S E R V I C E N O T E

E1401A VXI C-Size High-Power Mainframe

Serial Numbers: 3227A00101 / 3227A00267

Modification to prevent random system resets.

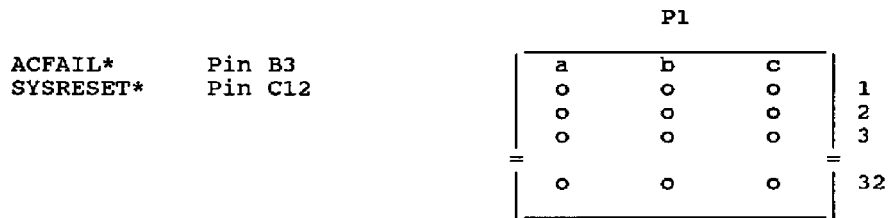
The cause of these random apparent failures may be noise on the system reset line (SYSRESET*) and/or the AC fail line (ACFAIL*) on the VXI backplane caused by inductive coupling in these signal lines from the fan power supply cable. These TTL lines are tied high (about +4 vdc), and are pulled low (< +1 vdc) when true. Noise spikes may drop the level low enough to cause reset to occur. The noise may be observed by monitoring these two signal lines on the 25-pin Sub-D connector on the rear panel of the E1401A (pin #10 is SYSRESET* and pin #23 is ACFAIL*). The signals can also be monitored on the front side of any one of the P1 (upper row) backplane 96-pin slot connectors:

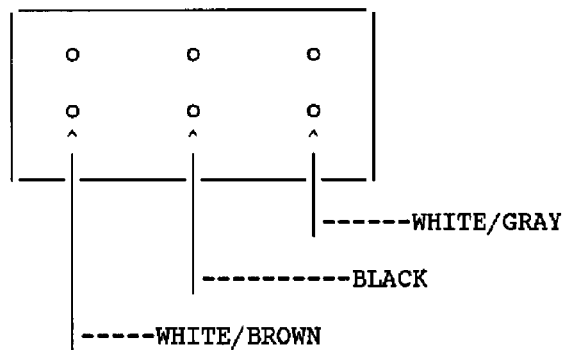
5. Examine the cable assembly leaving the white 13-pin connector. The three wires going to the upper right 6-pin connector on the backplane should be routed by themselves to the right side of the mainframe, and then upward to the backplane connector. The other 10 wires should be tie-wrapped together and should be pressed down into the cavity below, as far away from the three signal wires as possible.

At the end of the 3 wires with the 6-pin connector, record the wire colors going to the pins so they can be re-installed correctly (see below). Remove the three wires from the connector by using a sharp-pointed object to press in on the pin-release spring while applying tension to the wire. Slide a ferrite sleeve over the three wires and secure it to the wires about 3-4 inches away from the end of the wires using a tie-wrap at each end of the sleeve. Re-install the three pins in the connector:

6. Install a cable support in the hole on the side panel of the mainframe near the backplane connector and route the three-wire cable with the ferrite sleeve into the cable support to relieve stress on the connector, then re-install the connector.
